## AGENDA

2. ACTION: Recommendation to review and provide direction on the Design Review and Townhouse Preliminary Plat applications for the townhouse development at 310 Georgia Road. - Associate Planner, Paige Nied

STAFF REPORT  
KETCHUM PLANNING AND ZONING COMMISSION  
REGULAR MEETING OF APRIL 15, 2026

EXISTING DECK - BEFORE FIRE

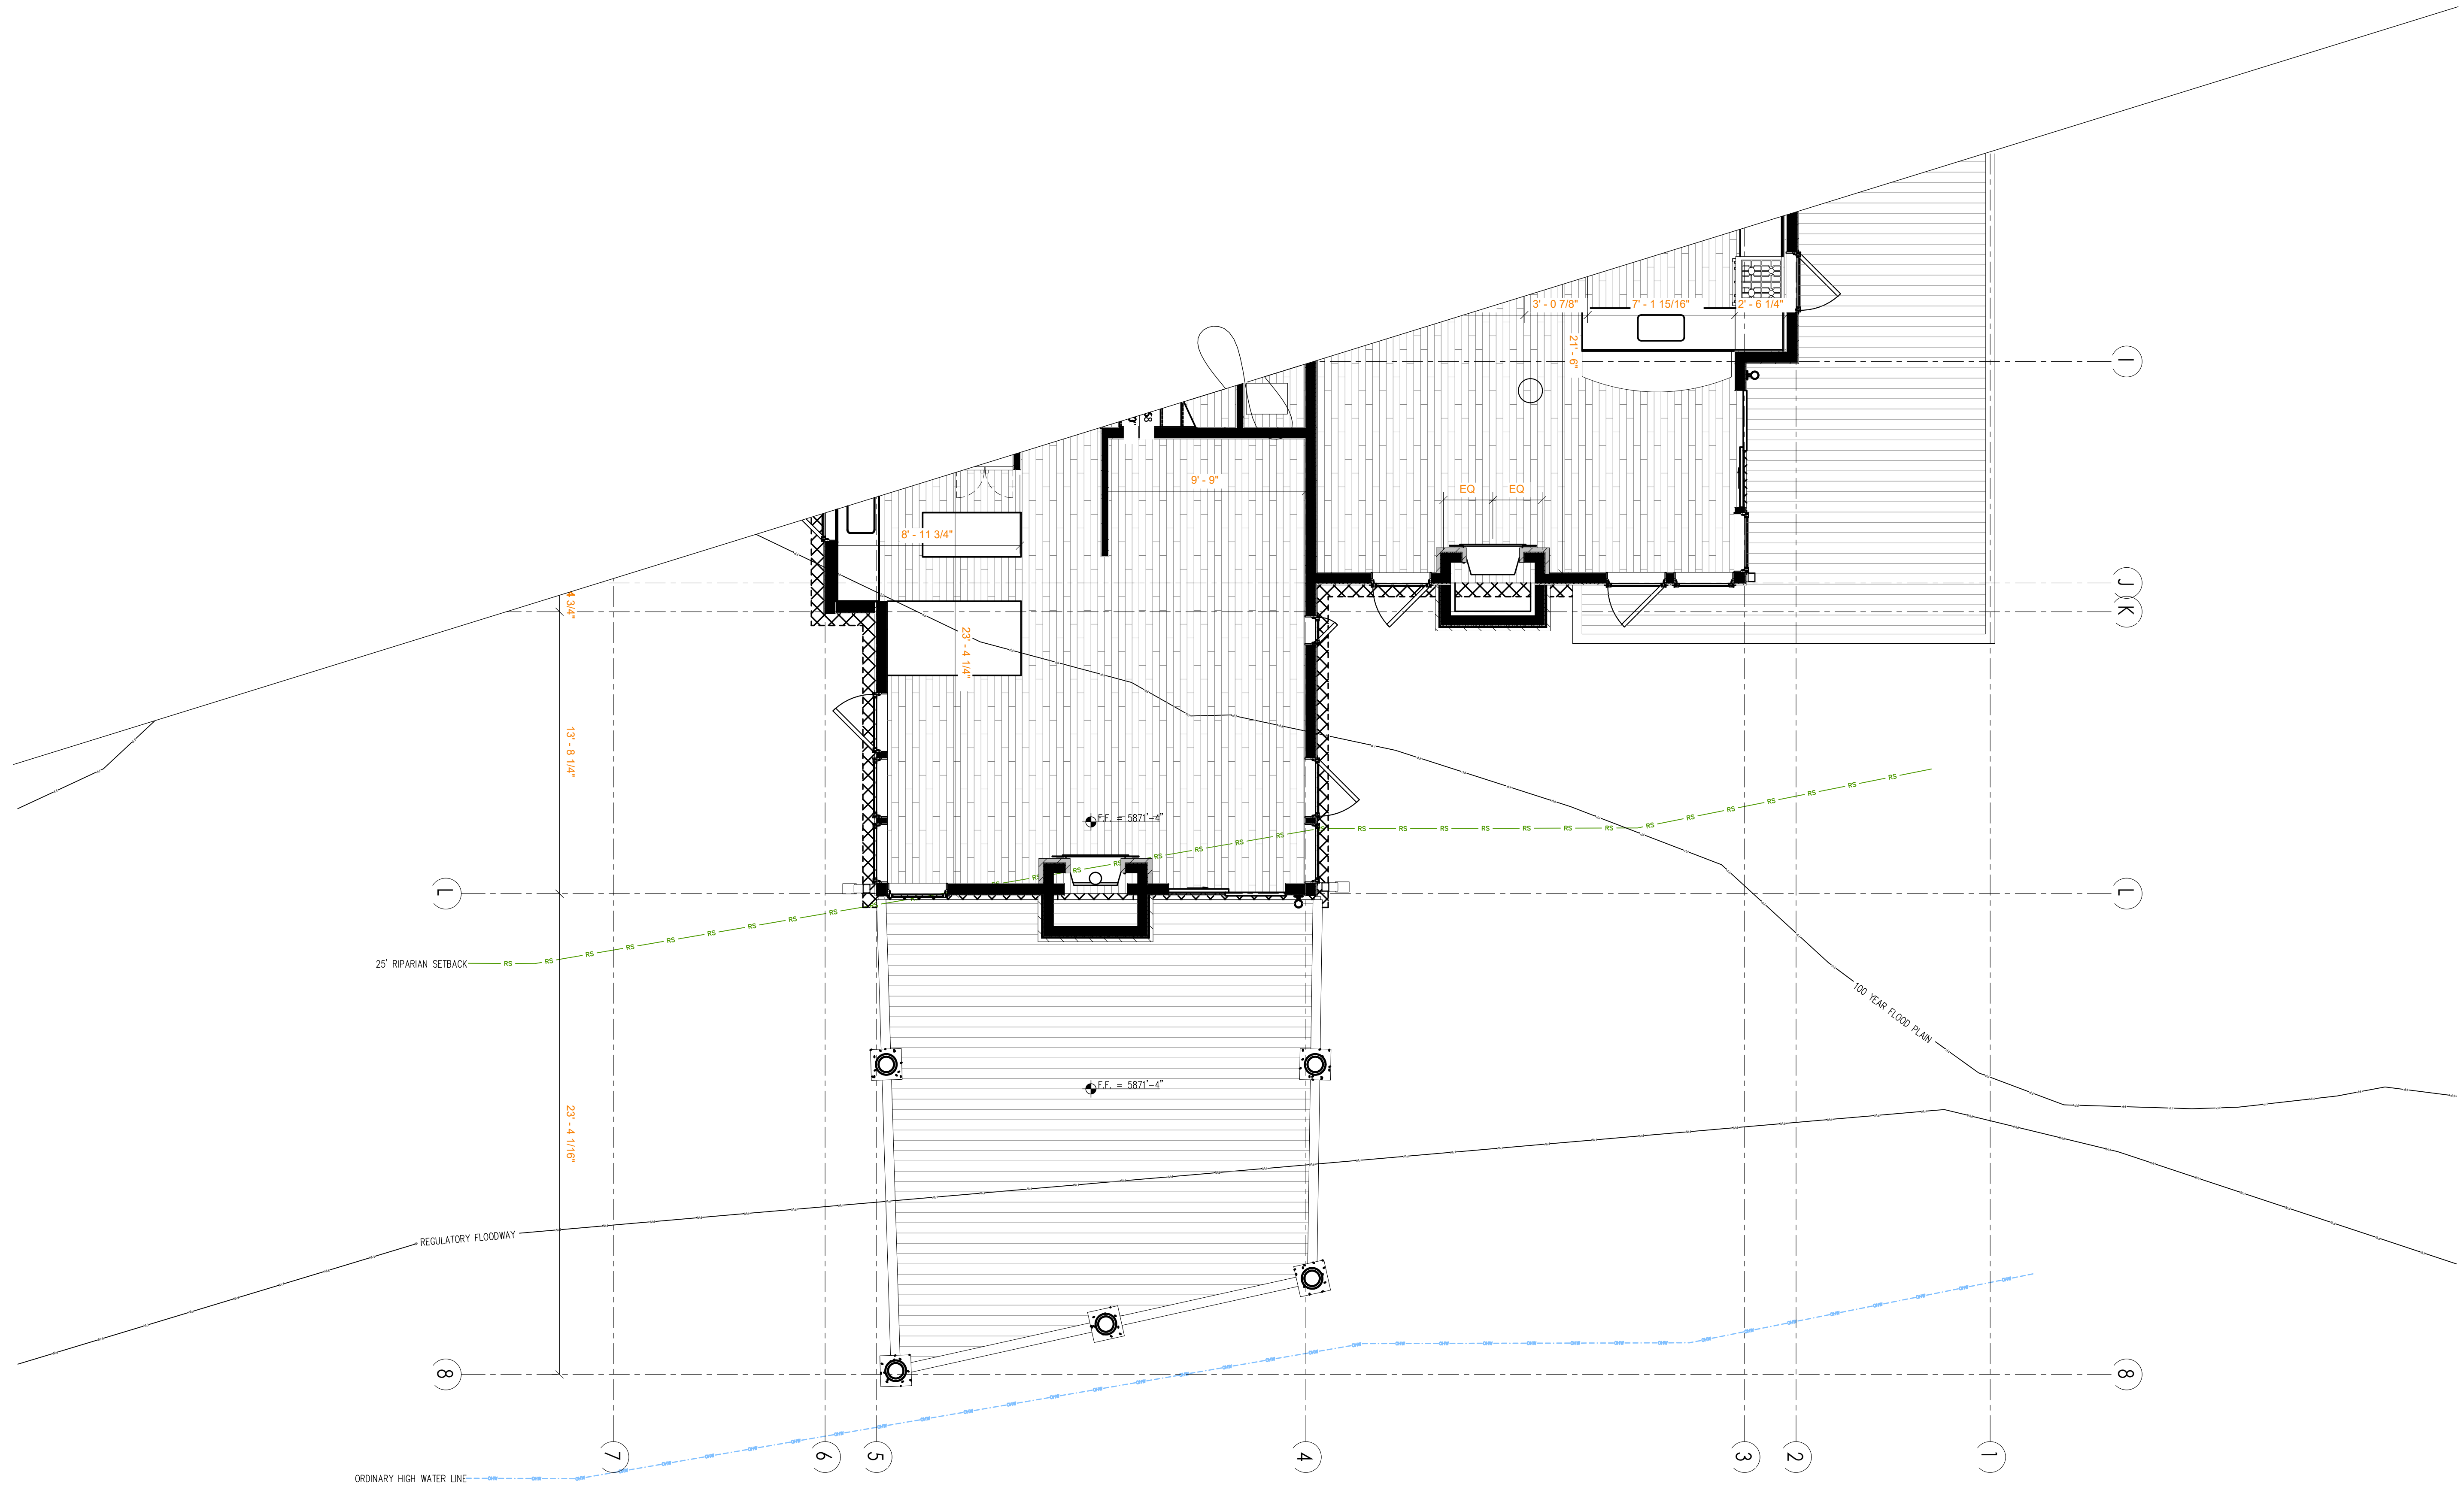
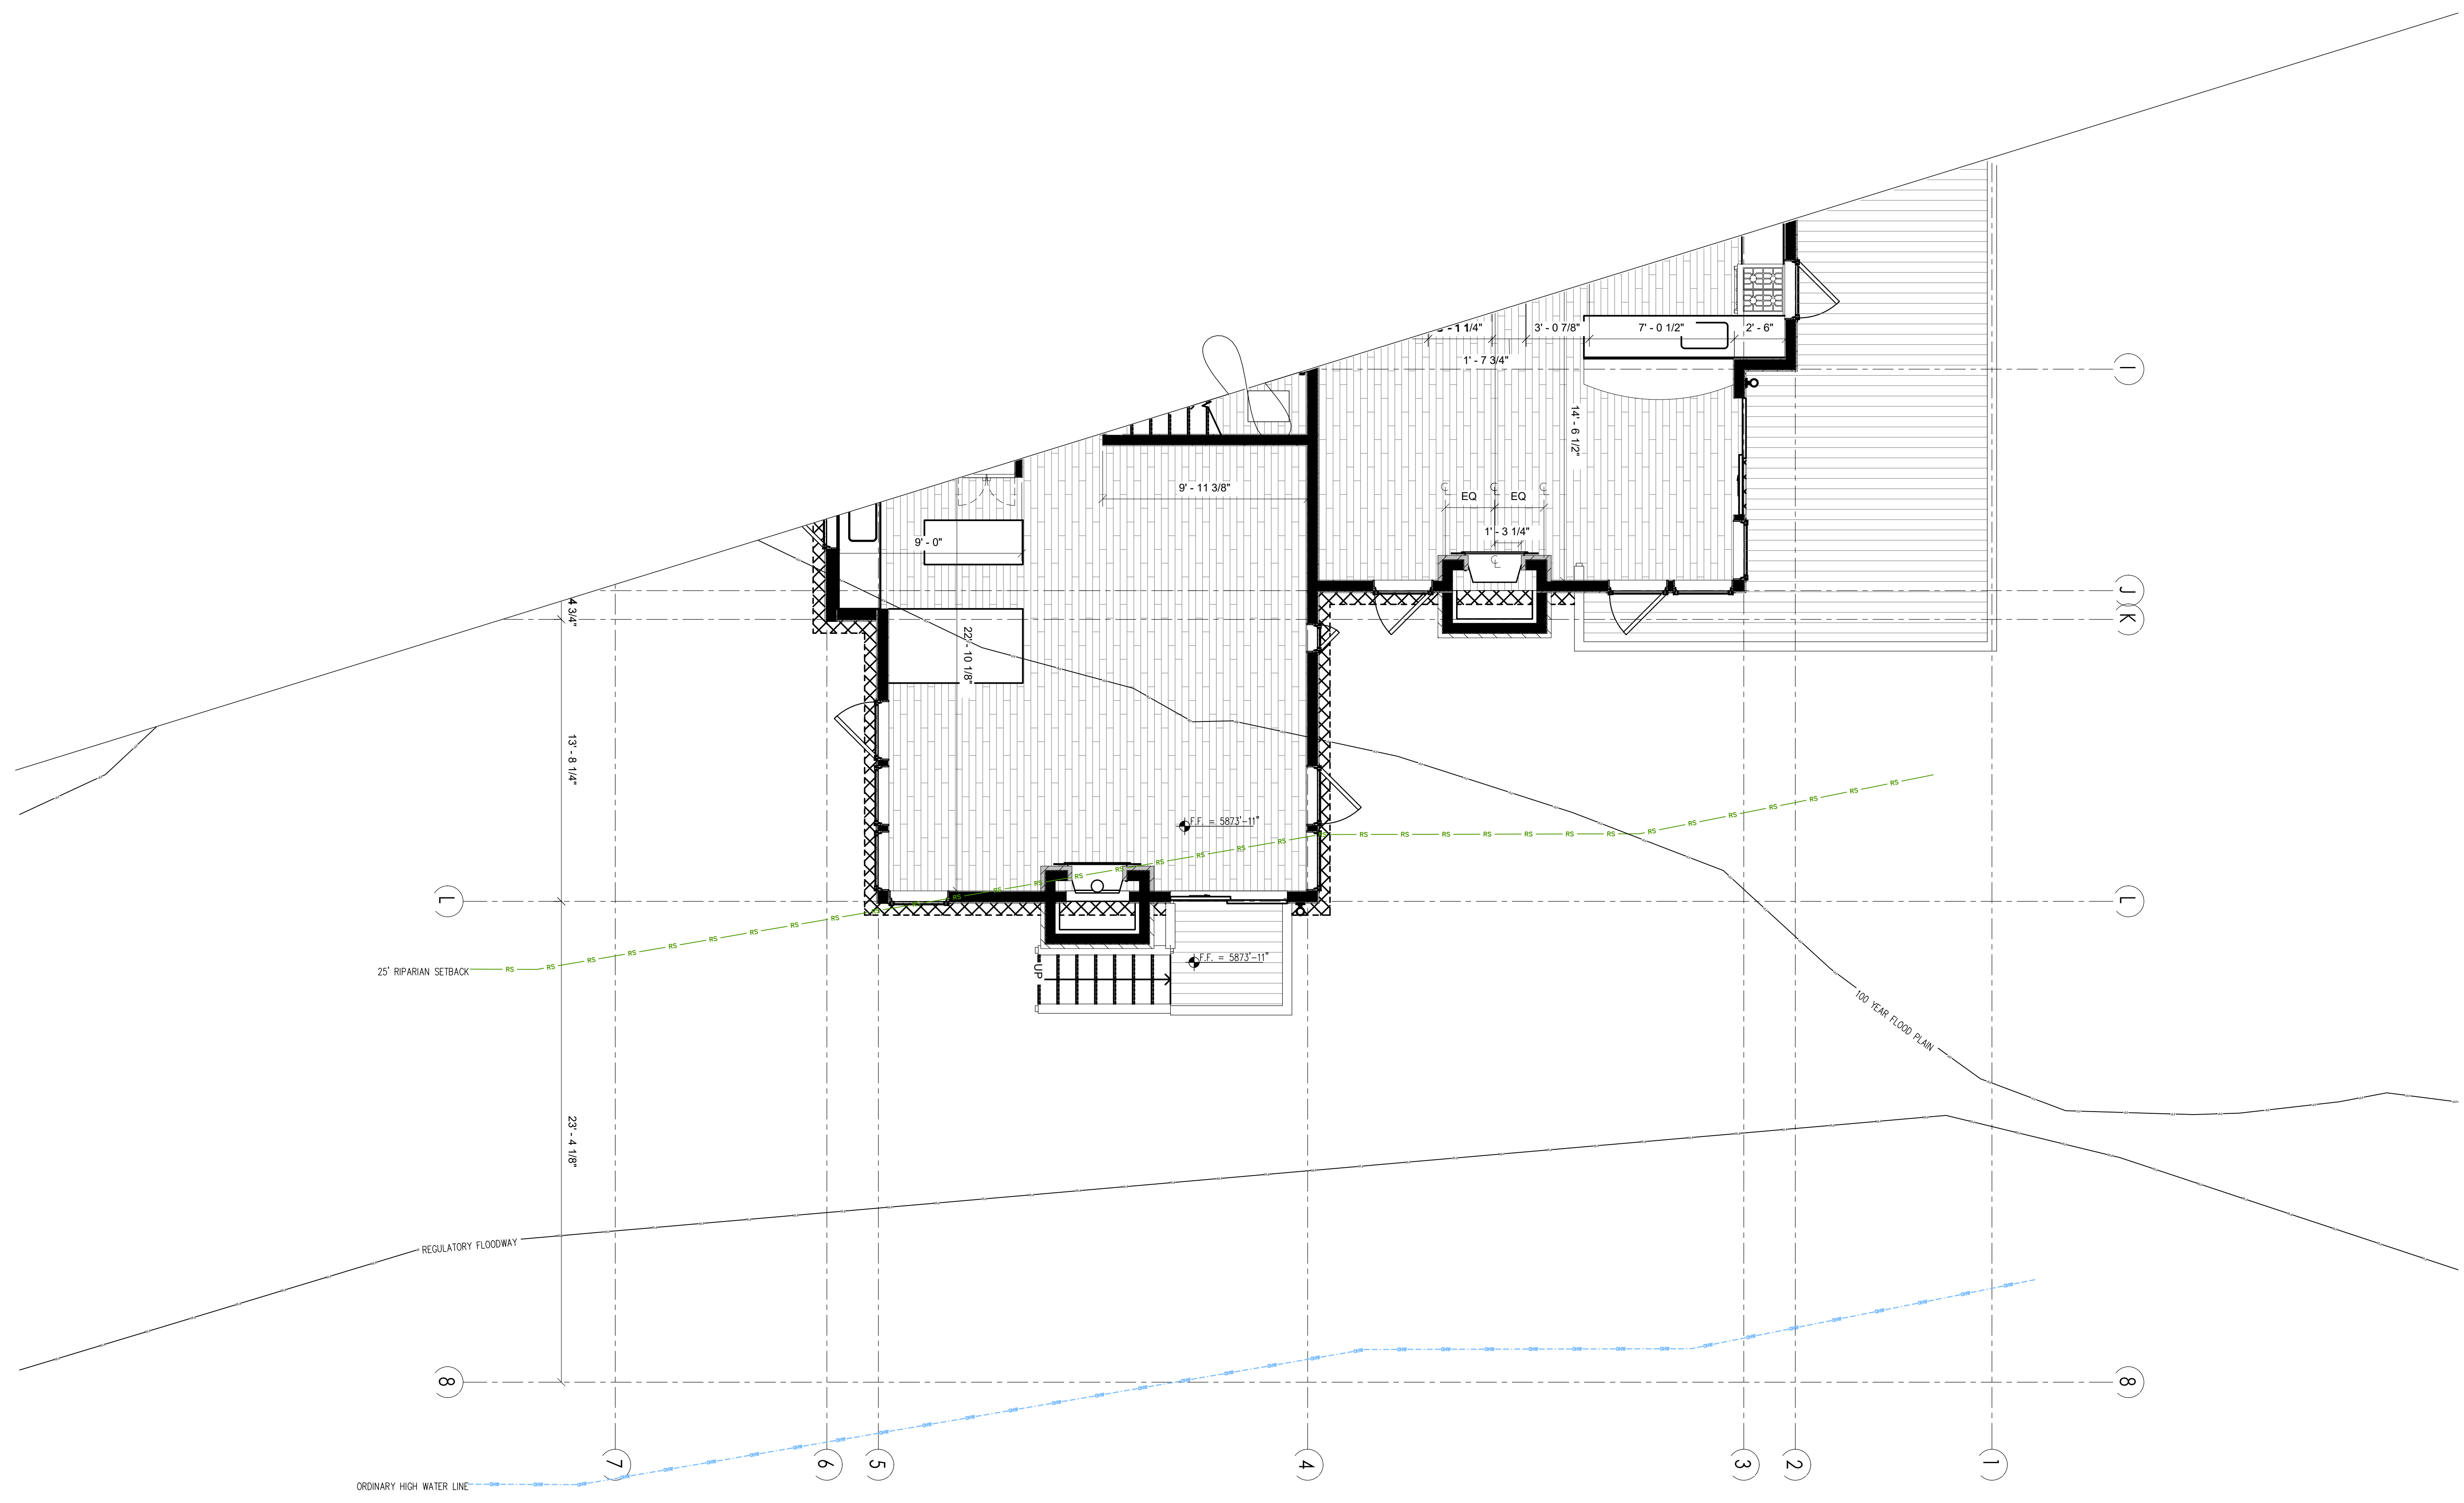
1	Comment: See comments related to resubmittals requested for the Floodplain Permit #P25-63 from Sarah Foster, Floodplain Manager. In addition, a deck determination letter will be made available from the Administrator with the direction <b>to omit the deck from the building permit set p. C0.20, A1.0, to be removed from the riparian setback excepting the landing.</b>
	Applicant Response:
2	Comment: See comment from Wastewater Department. The preexisting footprint of the structure is located 10' on top of the city sewer line. This is simply to make the property owner aware of the circumstance. Further conversations may be needed internally on how to best proceed if rerouting the line is necessary and/or feasible at this time.
	Applicant Response:
3	Comment:
	Applicant Response:
